2CAN011401

SUBJECT: Response to Request for Additional Information
Adoption of National Fire Protection Association Standard NFPA-805
Arkansas Nuclear One, Unit 2
Docket No. 50-368
License No. NPF-6

**120-Day Responses to Request for Additional Information
ANO-2 Transition to NFPA-805**

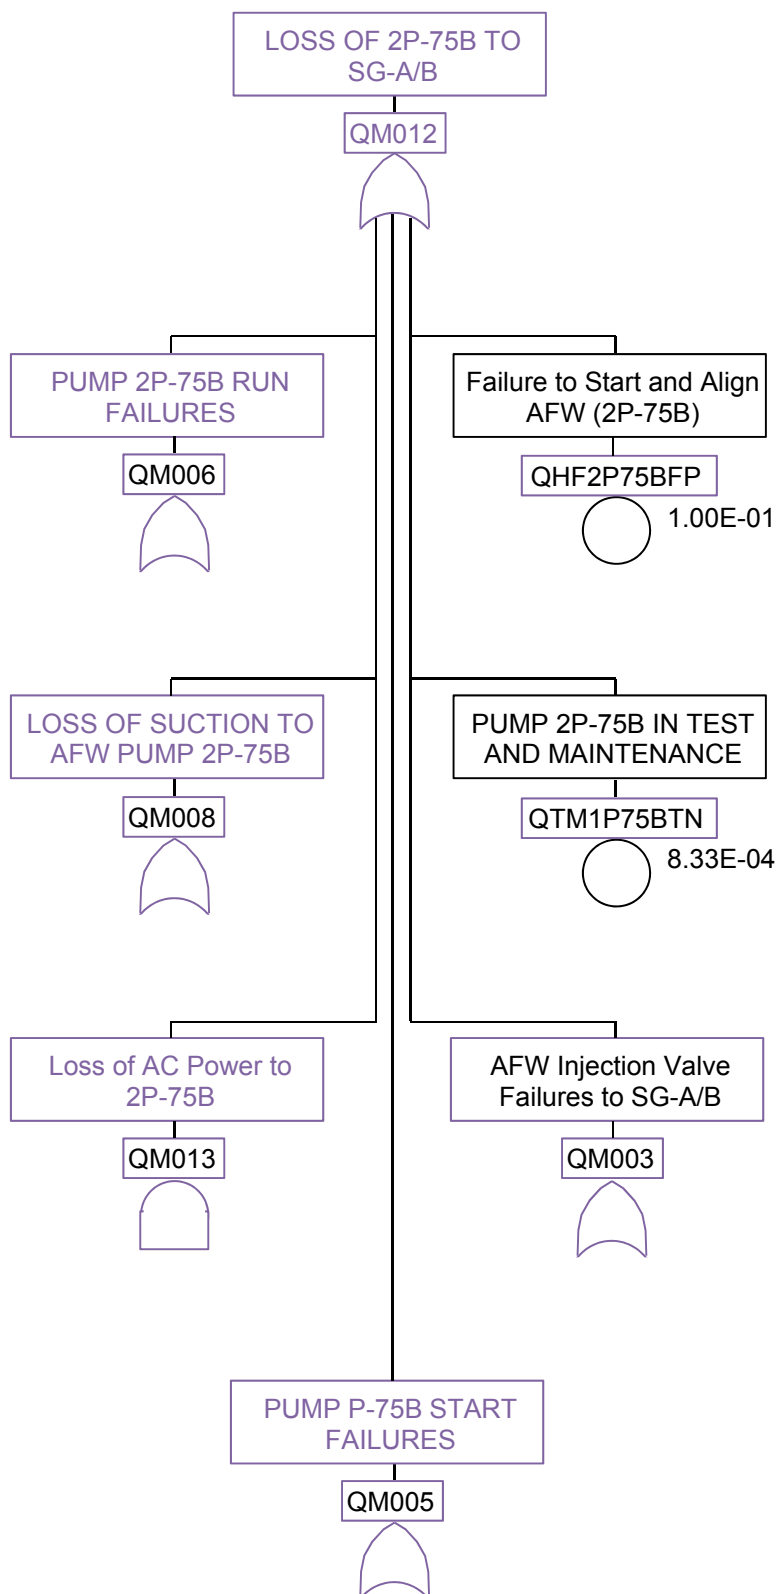
- Identify the proposed modifications that do not correct any VFDRs (i.e., that are installed solely to reduce risk).
- Summarize how the design of the new features has been provided to the PRA analysts for use in modeling the risk impact (e.g., as brief descriptions or completed design package).
- Summarize the new models that have been developed (e.g., what basic events, fault trees, event trees, and failure data).
- Describe how the effect of all new cables has been evaluated (e.g., have areas that credit for the new equipment is being taken been identified as areas where required cables may not be routed).

Two of the VFDR-related modifications (S1-11 installing a new AFW pump and S1-3 installing backup DC control power to the switchgear) are more complex than the others and will be discussed in the remainder of this response. Scoping descriptions of these modifications were developed collaboratively between the PRA analysts and the modification scoping engineers as described below.

For modification S1-11, the PRA analysts determined that an additional, diverse source of feedwater, with both local and Control Room control capability, could mitigate many VFDRs and reduce risk in several different fire areas. After studying the circuit drawings and component locations, the modification scoping engineers proposed a location for the new pump (Fire Zone 75-AA in ANO-1) and additional considerations for diverse power, valve locations, controls, etc. Next, the PRA analysts developed a fault tree for the new pump and auxiliaries. Then meetings were held in which the PRA analysts and modification scoping engineers refined the fault tree, the Fire PRA assumptions, and the modification description for consistency. The resulting Fire PRA fault tree is provided in the response to c), below. In developing the final design package, any deviations from the original assumptions will be communicated back to the PRA analysts, will be evaluated within the Fire PRA model, and the impact on risk will be assessed to ensure that the total risk will remain within regulatory limits.

For modification S1-3, the PRA analysts communicated a desire for a modification that could ensure one train of DC power remains available for remote breaker control. The modification scoping engineers proposed that the addition of a redundant DC power supply to the switchgear would be the most feasible manner in which to address this need. The modification scoping description provided in LAR Table S-1 was provided to the PRA
